RECEIPT DATE: 9/29/20 **ONSITE SEWAGE DISPOSAL SYSTEM** P 567996
 APPROVAL DATE: 11/18/2020 (SS) **PERMIT: CONSTRUCTION** A _____
 PROPERTY ADDRESS: 12245 Mayapple Drive
 SUBDIVISION: Walker Meadows LOT: 33 TAX ID: 03-601591
 CONTRACTOR: South Carroll Backhoe EMAIL: sbackhoe@comcast.net
 CONTRACTOR ADDRESS: 4410 Salem Bottom Road, Westminster, MD 21157 PHONE: 410-596-3618

WALL CHECK
12245 MAYAPPLE DRIVE
LOT 33
WALKER MEADOWS
PLAT NO. 24977
3rd ELECTION DISTRICT HOWARD COUNTY, MD

RE: **Septic Pre Construction Inspection_12245 Mayapple Drive_(P 567996)**

LOT 33
REVISED BAT PLAN

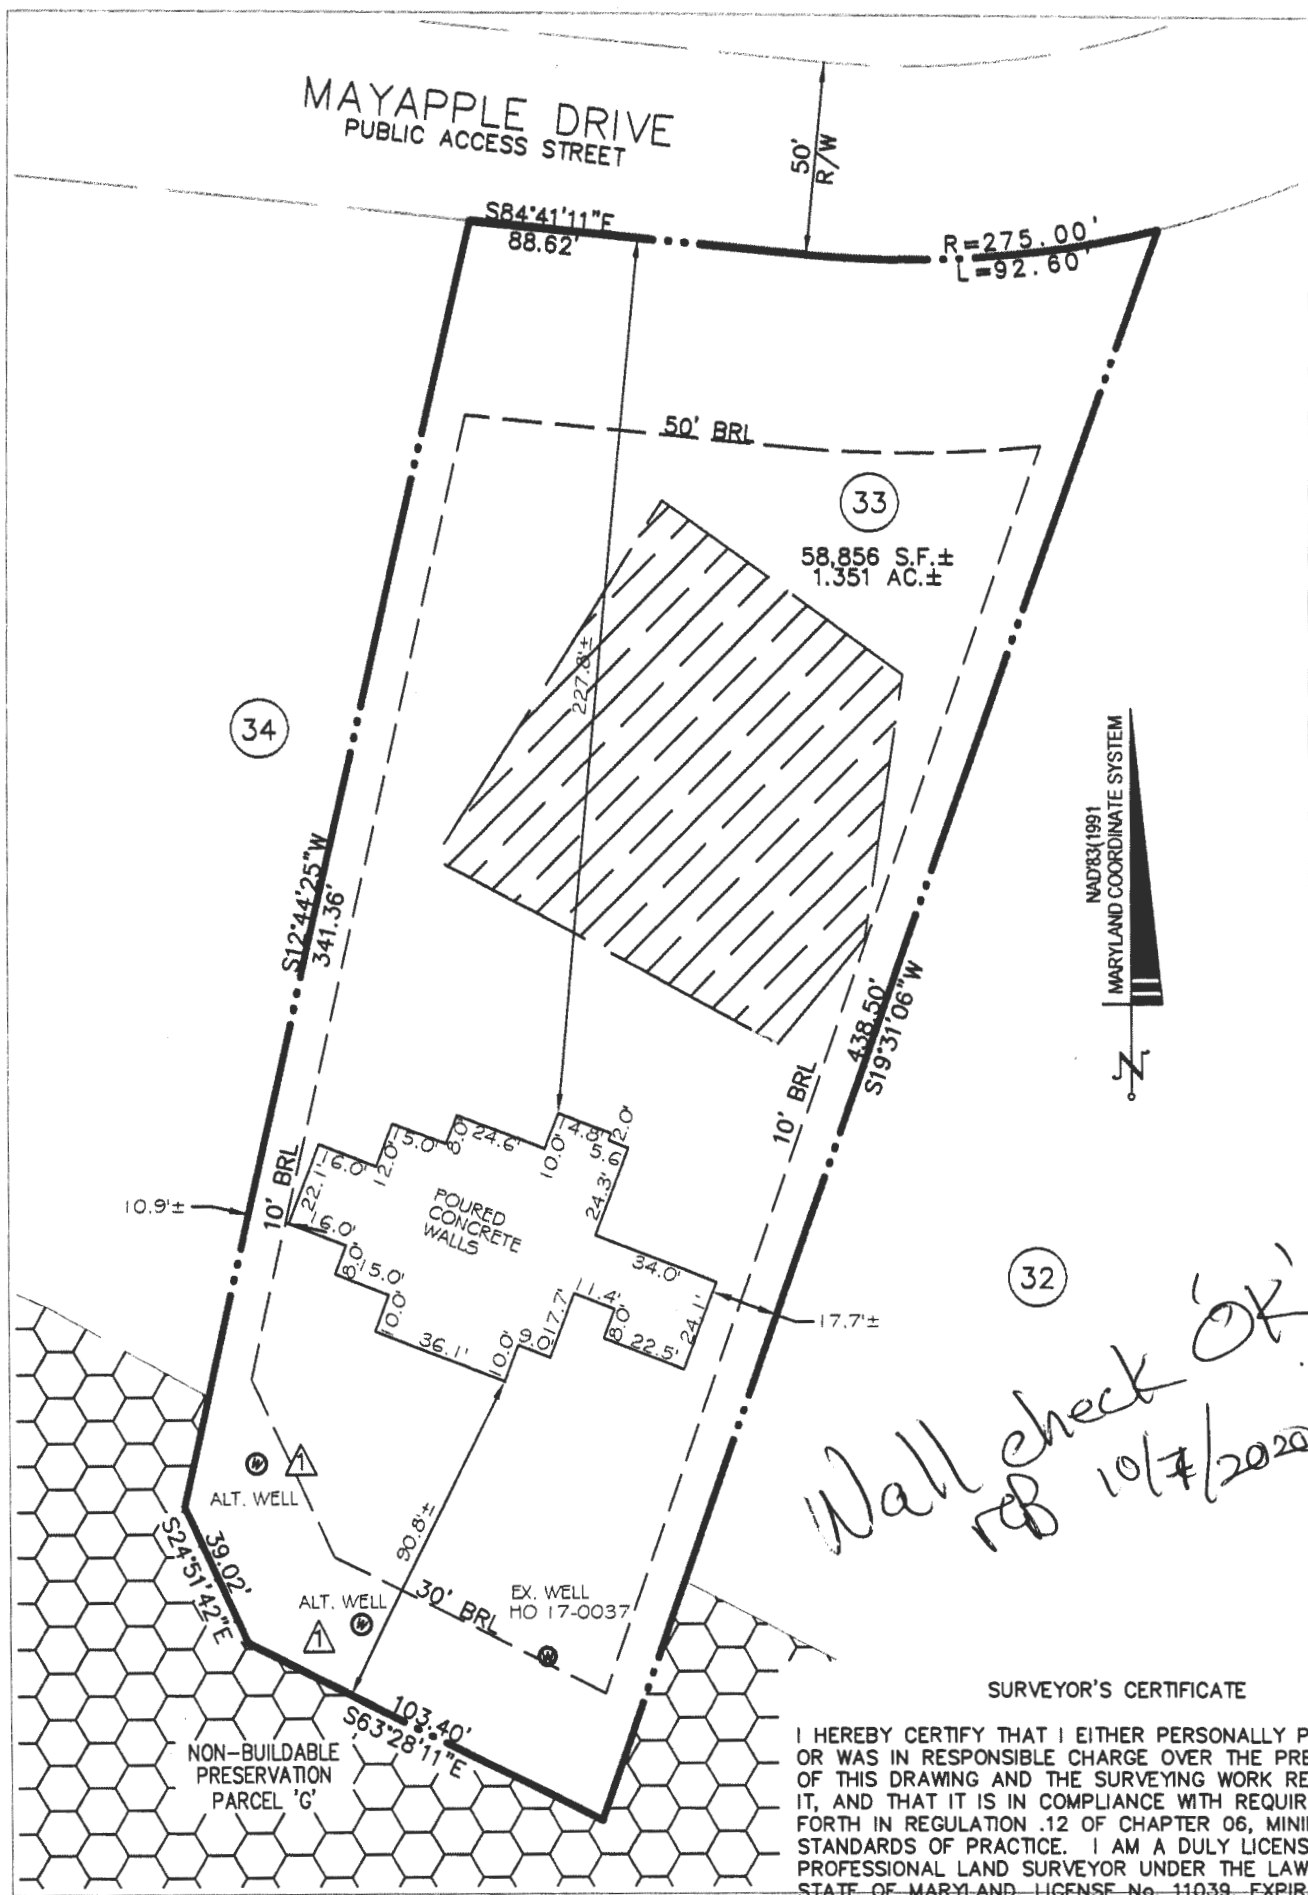
I have reviewed the 'Wall Checks' for lots 33 and 34 in the Walker Meadows subdivision and found both to be faulted.

Both wall checks as submitted on 8.5"x14" sheets are not at the 1:50 scale. This is most obvious on the Lot 33 measurement of 227.8' and the Lot 34 measurement of 121.1'. Both of these distances are 5' different from their labels.

I have reviewed 'Wall Checks' for Lots 33 and 34 in the Walker Meadows subdivision and found both to be faulted.

1. As submitted on 8.5" x 14" sheets, neither of the drawings are at scale.
2. Neither of the drawings include the Alternate wells' locations which are required content on foundation location surveys.
3. On the drawing for Lot 34, the distance label from front line to front-right corner of foundation is not accurate.

*Wall check OK
RB 10/7/2020*

REVISION TO ADD ALTERNATE WELL LOCATIONS 10/5/20

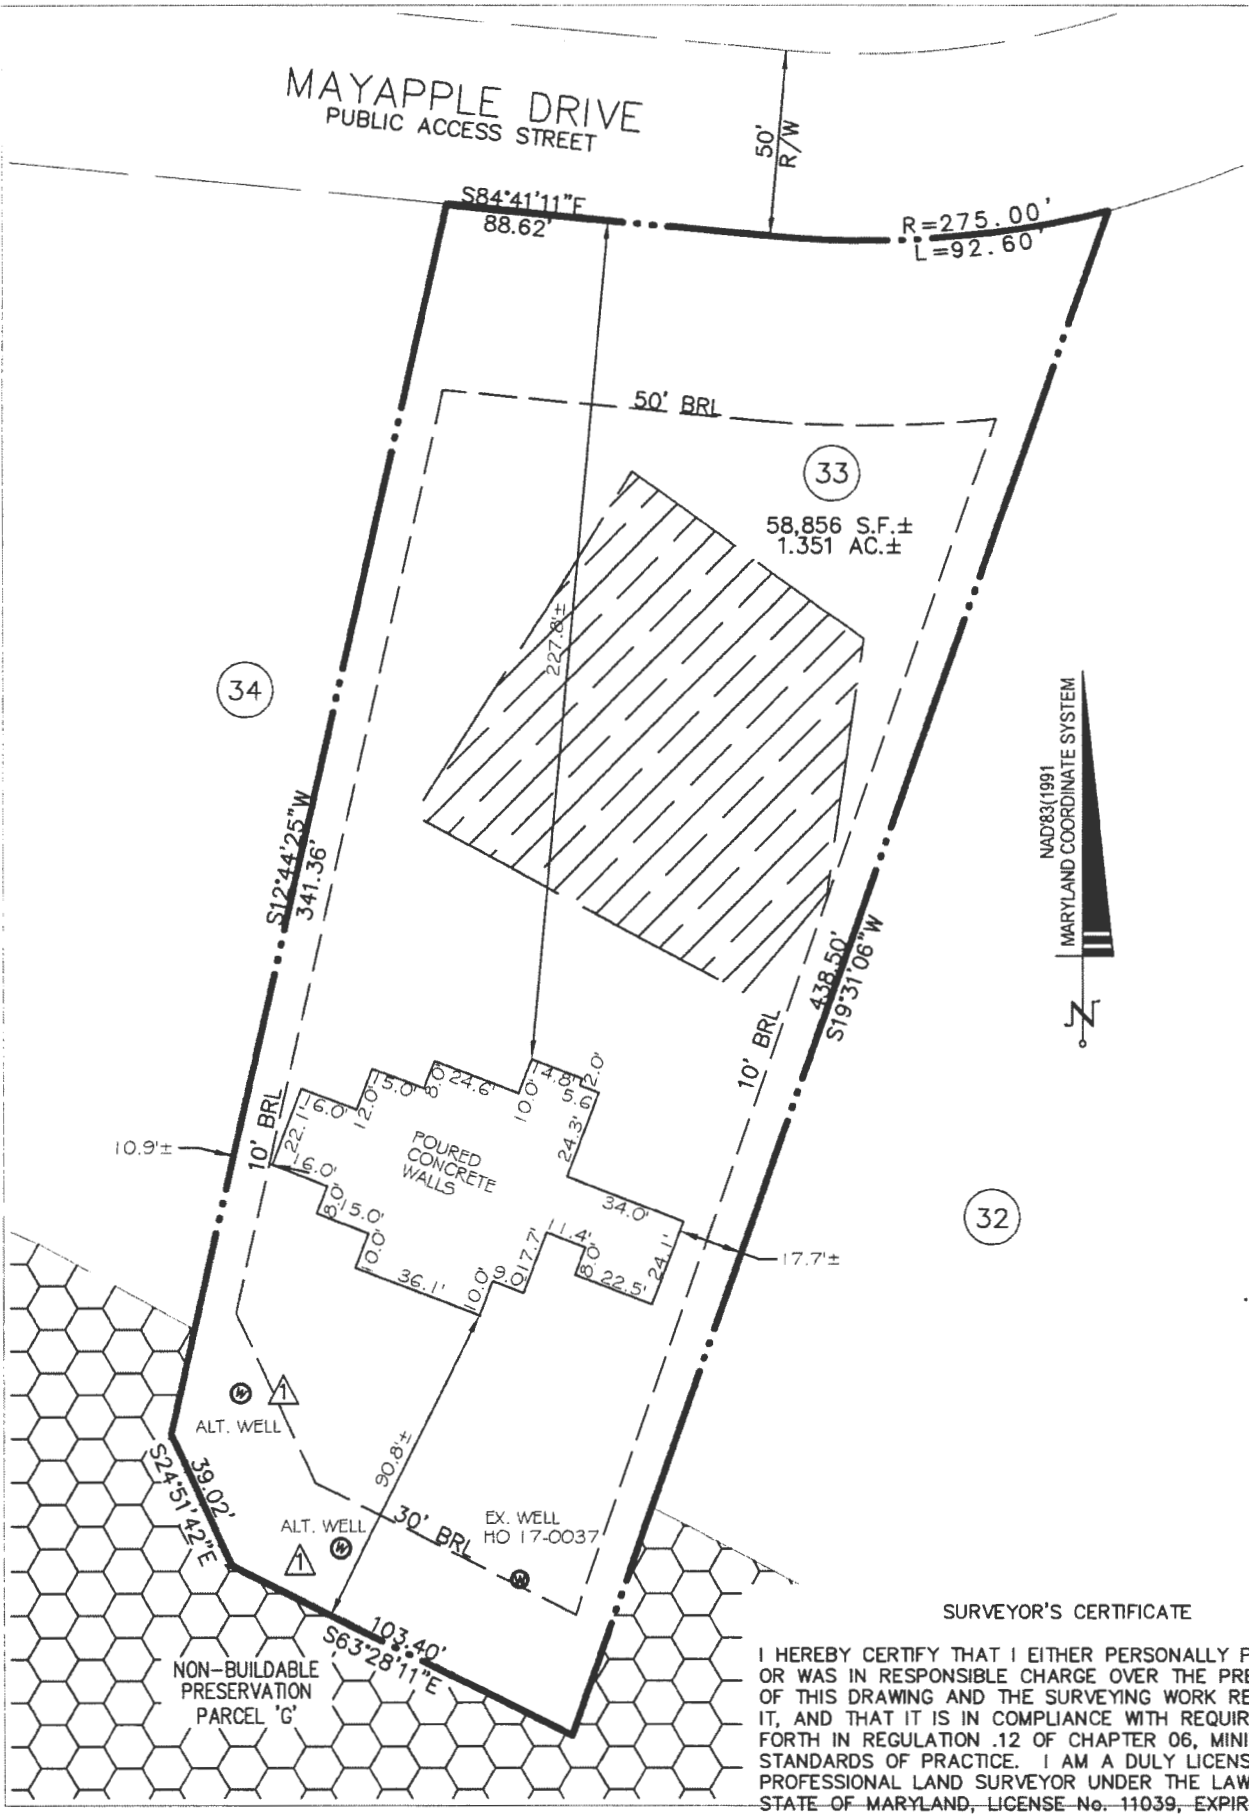
Hi Lori,
I marked three locations on this photocopy: two on the south side of a garage (between the doors, or on the south wall near the back corner, and a location on the north wall near the 564.0 elevation label. What do you think?
Robert Bricker

Lori, I forgot to check the Control Panel location on Lot 33. Send me a proposed location so that I can mark it on the plan. Thanks

Let's go with the north wall near the 564.0 elevation label.

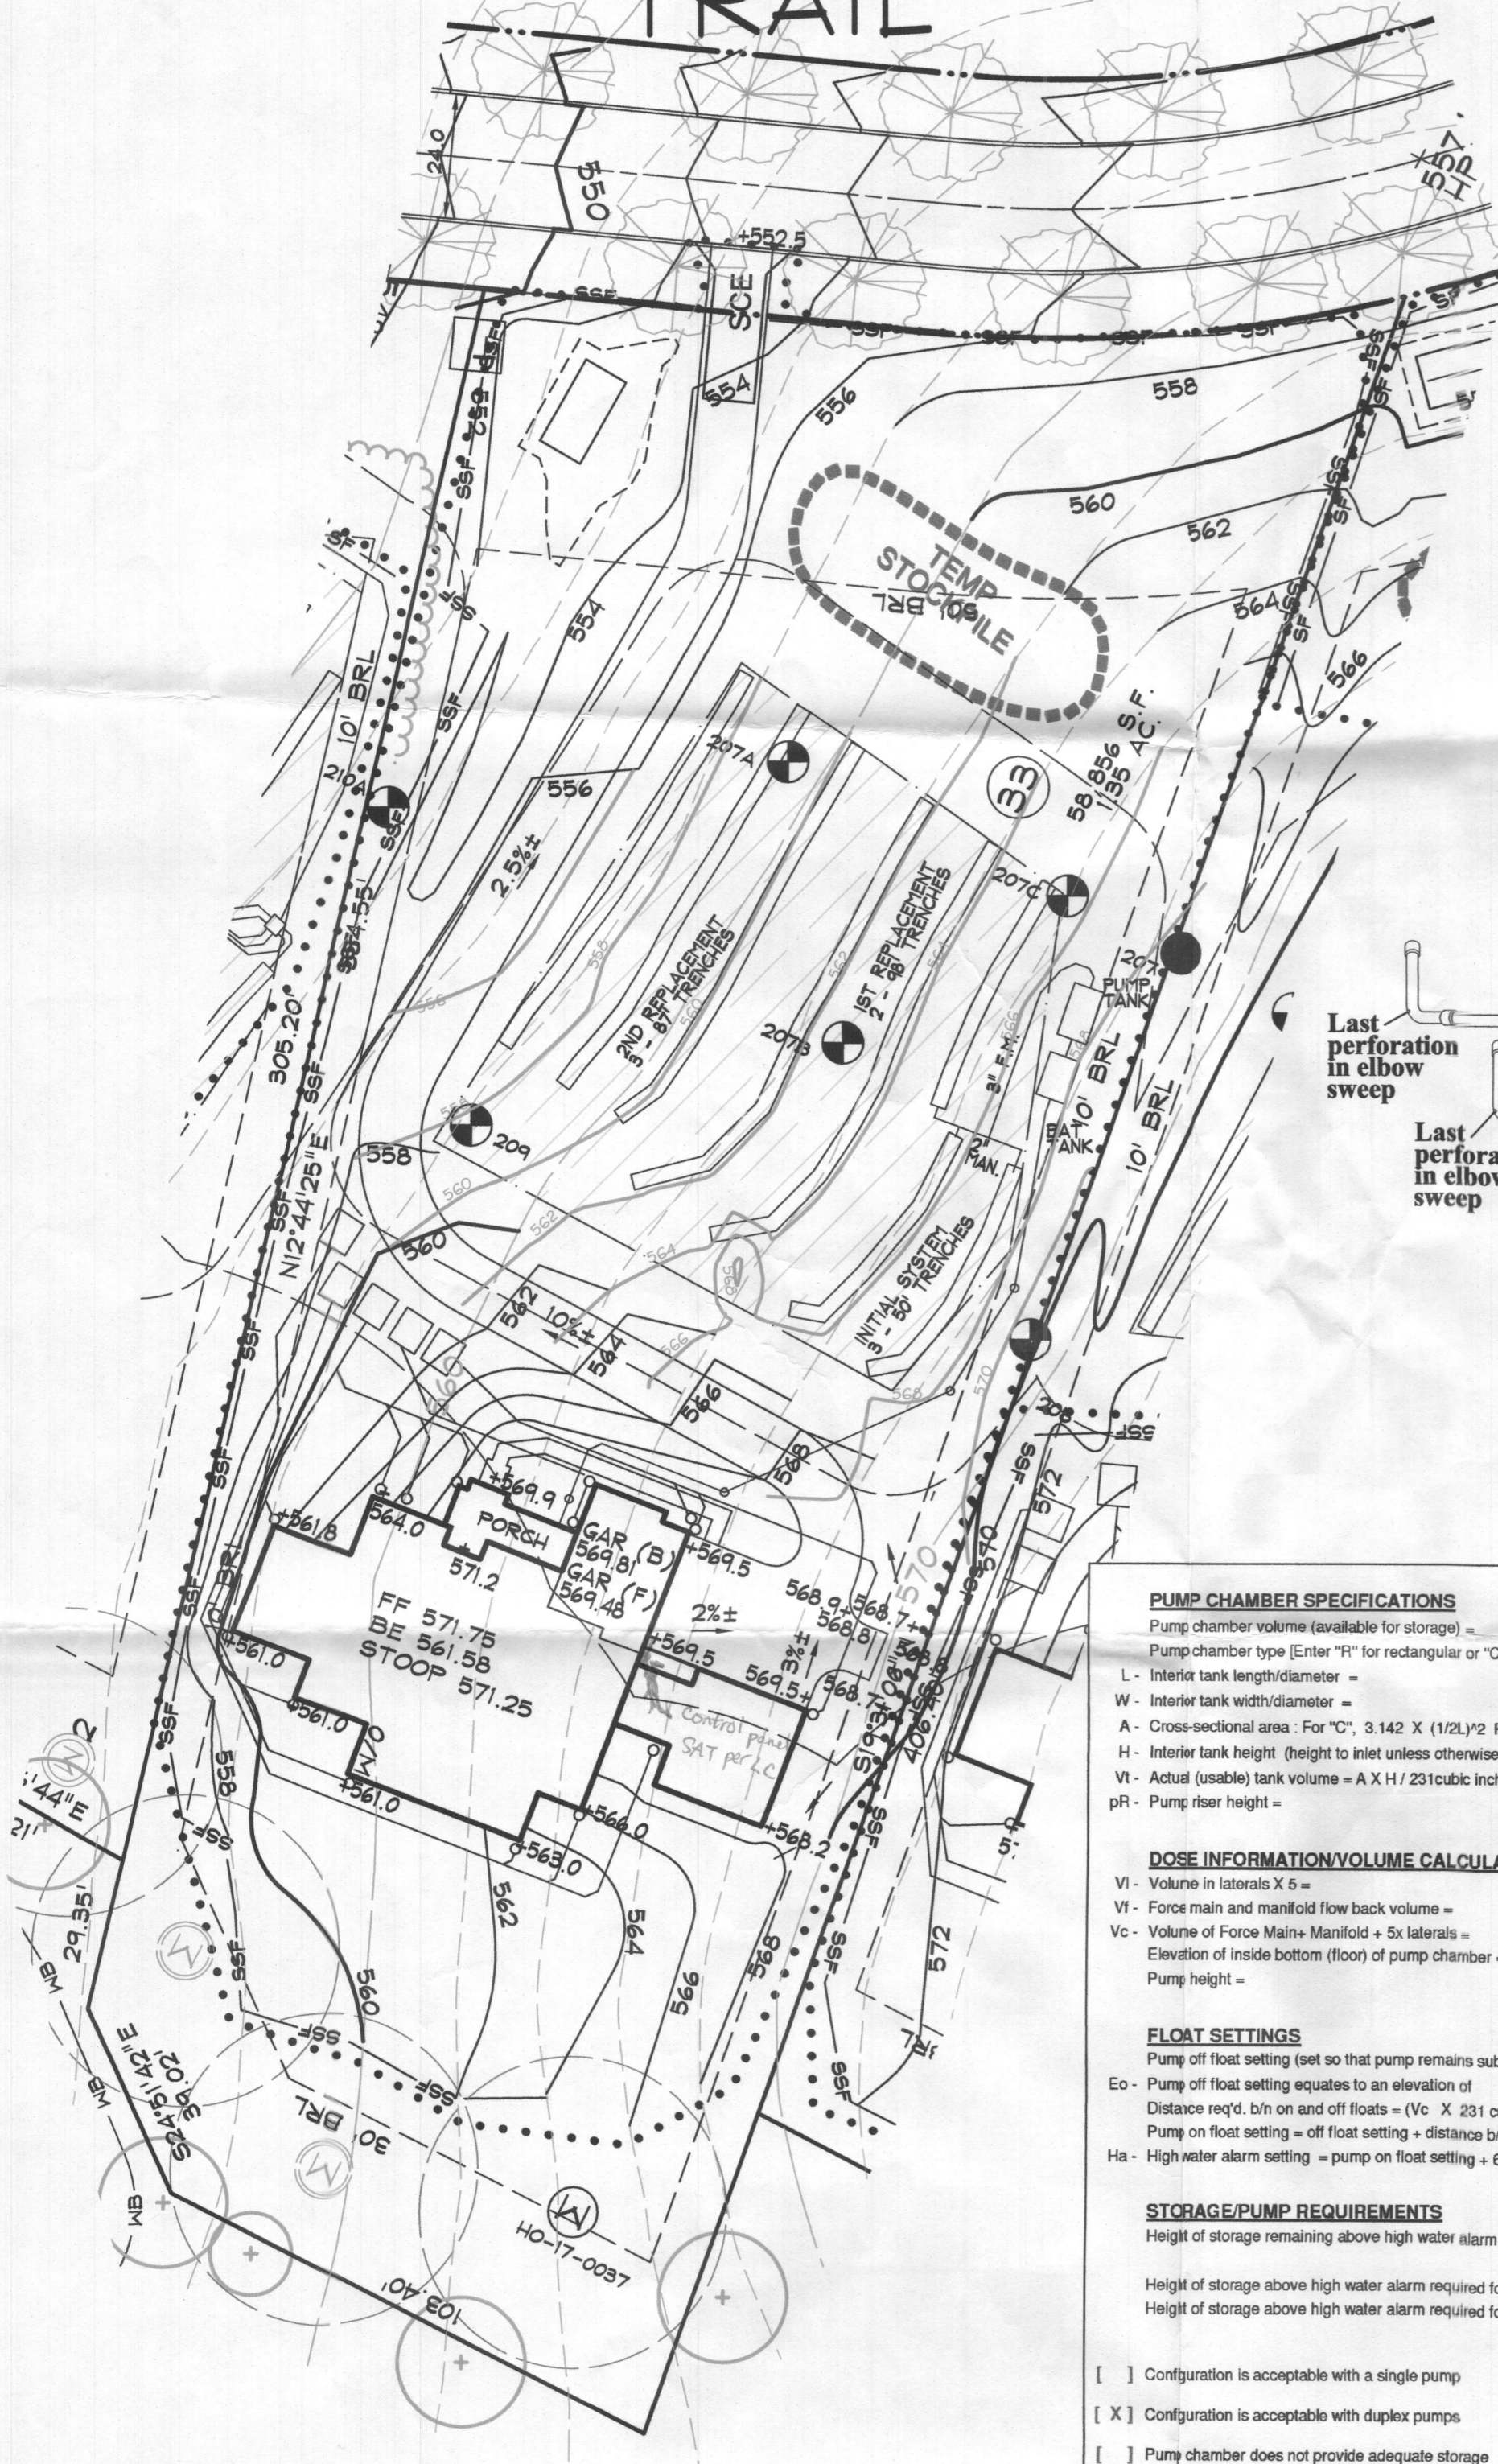
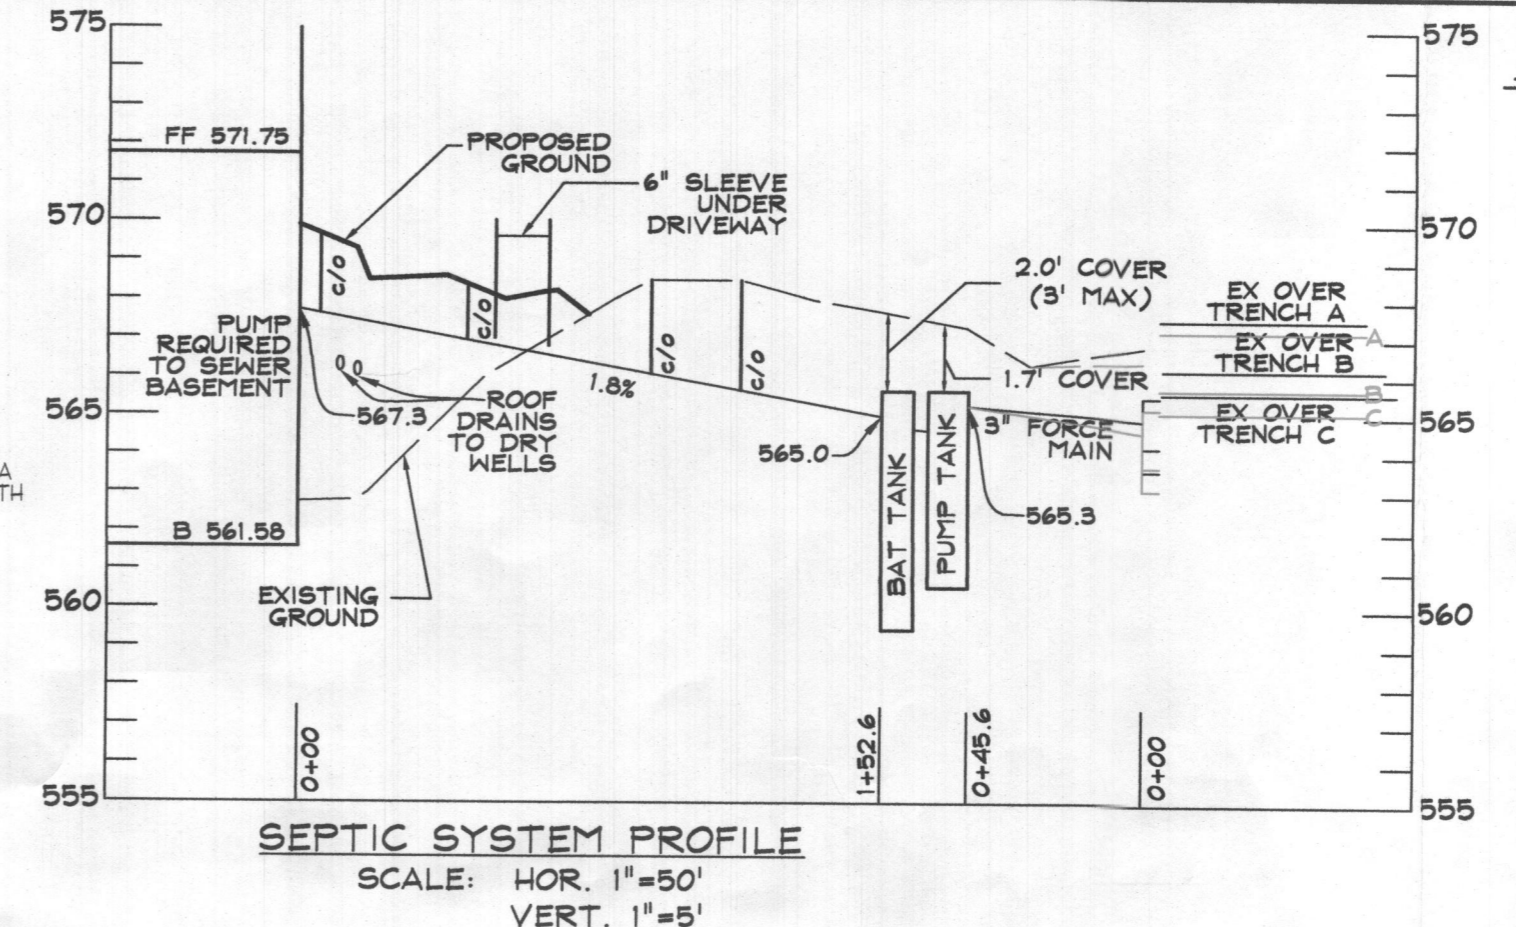
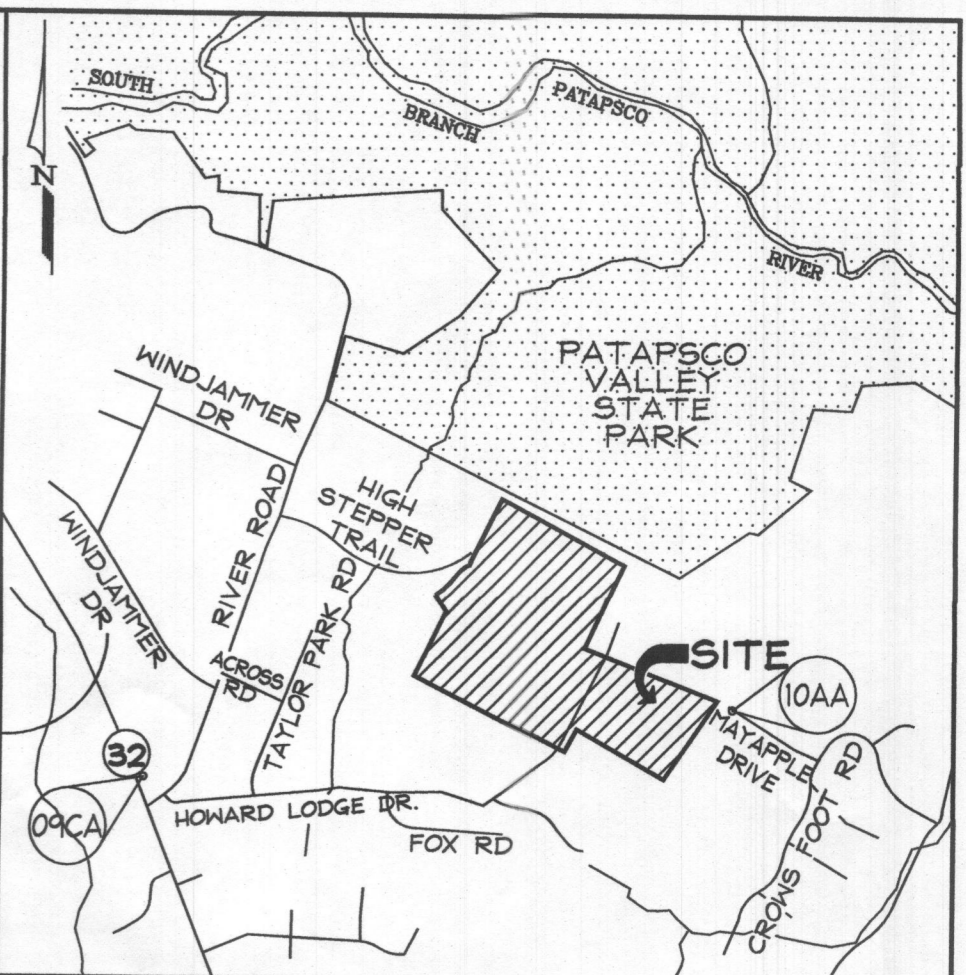
- The sewer house connection was relocated out of the house, reducing fall substantially from the 1.8% proposed on the OSDS and raising the inlet under the driveway. The minimum fall required is 1.0%, if the system cannot be installed to meet the minimum 1.0% fall, the Septic System will not be approved.

- The elevation difference between the proximal and distal ends of Trench A was observed, using a laser level, to be 24". The maximum difference allowable is 6".

- The elevation difference between the proximal and distal ends of Trench B was observed, using a laser level, to be 17" with 9" of discovered fill. The maximum allowable difference is 6".

- Construction activities were evident over the septic disposal area. The designed systems are 2' invert low pressure dose trenches. Construction traffic, activities, and heavy machinery can compress the soil, changing the loading rate. A note has been added to the file.

In order to move forward, the Septic Disposal Area must be returned to original contour.
